# PERMIT

SEWAGE DISPOSAL SYSTEM

MARYLAND STATE DEPARTMENT OF HEALTH

*PT 40 - 600 ft east of St. John's Lane*

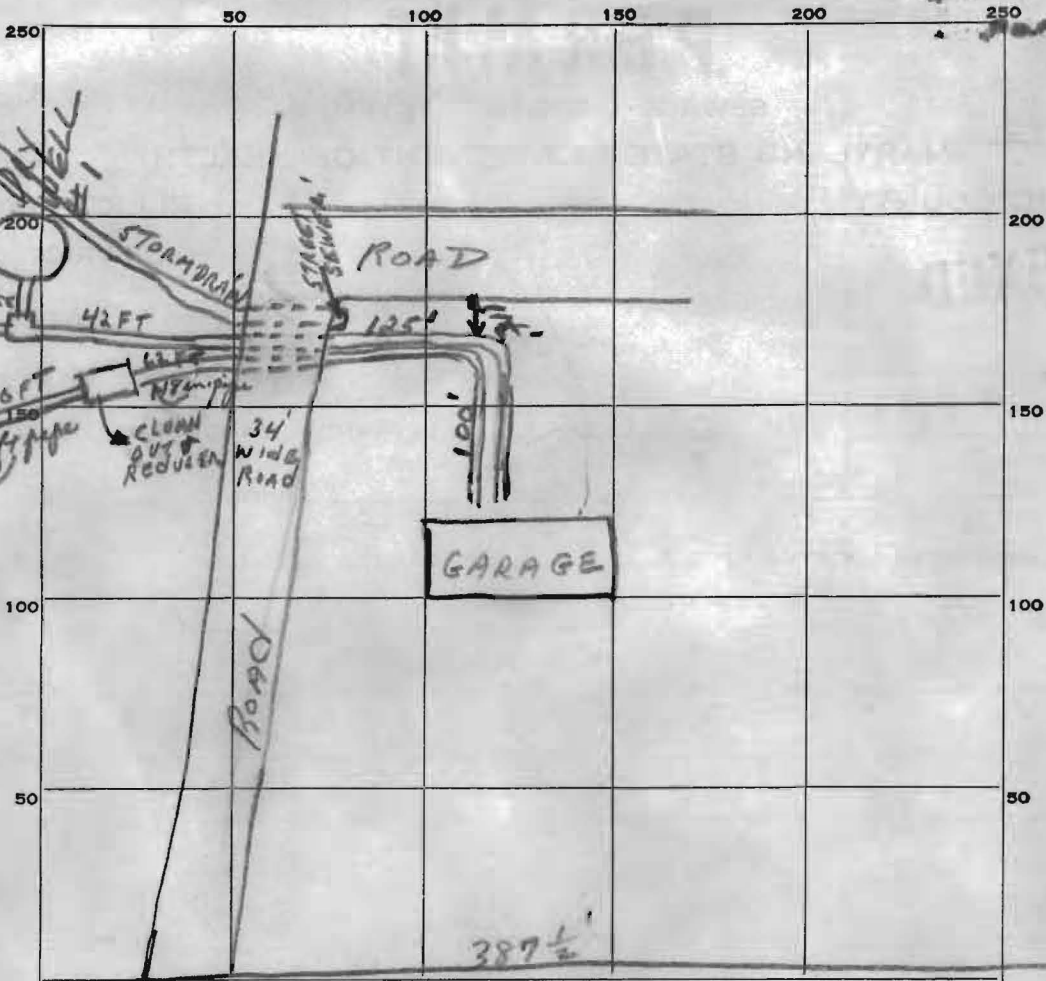
10-17-62 Need more stone in dry wells. JH

grease traps not installed. 10-19-62 Told man who works for S. Frigo to call for inspection on grease traps. JH.

10-18-62 Stone in dry wells ok. up to cover. JH. OK to approve layout
